**SIERRA CLUB
NATURAL RESOURCES DEFENSE COUNCIL**

January 3, 2012

**RE: Comments on Draft Construction Permit, I.D. No. 021060ACB, for the
Proposed Taylorville Energy Center**

Figure 1
The Effect of Averaging Time on Pollutant Concentration²⁵¹

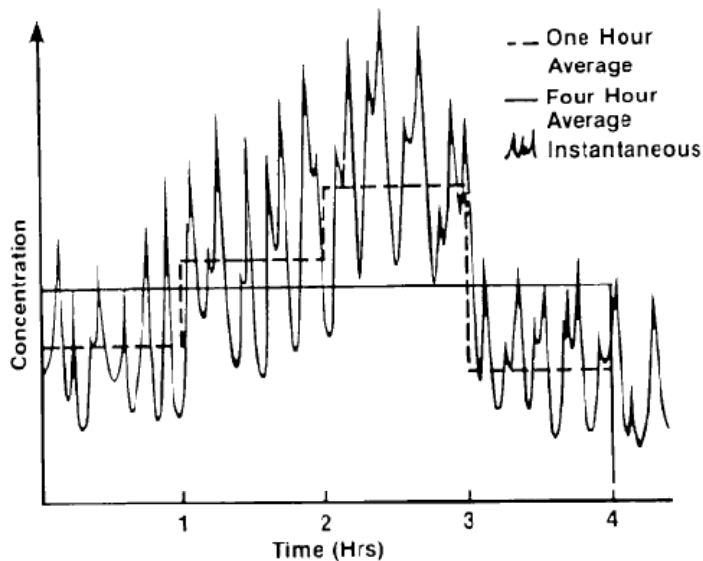
The averaging time is the time period over which a limit is averaged. A 3-hour rolling average averages the data in 3-hour chunks, moving forward 1-hour at a time. A moving average smooths out short-term fluctuations in the data. The shorter the averaging time, the more stringent the emission limit as there is less time to average out short-term spikes. This is shown by Figure 1 which shows that the 4-hour average conceals the considerably higher short-term spikes.

The averaging time is part of the BACT determination.²⁵² The shorter the averaging time, the more stringent the emission limit. The Applicant must demonstrate that the BACT limit is the emission rate based on the maximum degree of reduction that is achievable. This demonstration has not been made and, in fact, is refuted by information in the record. Appendix D of the Application summarizes BACT determinations for other similar facilities. This summary includes 36 BACT determinations for NO_x for similar gas turbines at 2 ppm. Of these, 14 are based on a 1-hour averaging time.²⁵³ The Application contains no explanation for why these more stringent BACT determinations for similar turbines firing natural gas are not NO_x BACT for Taylorville.
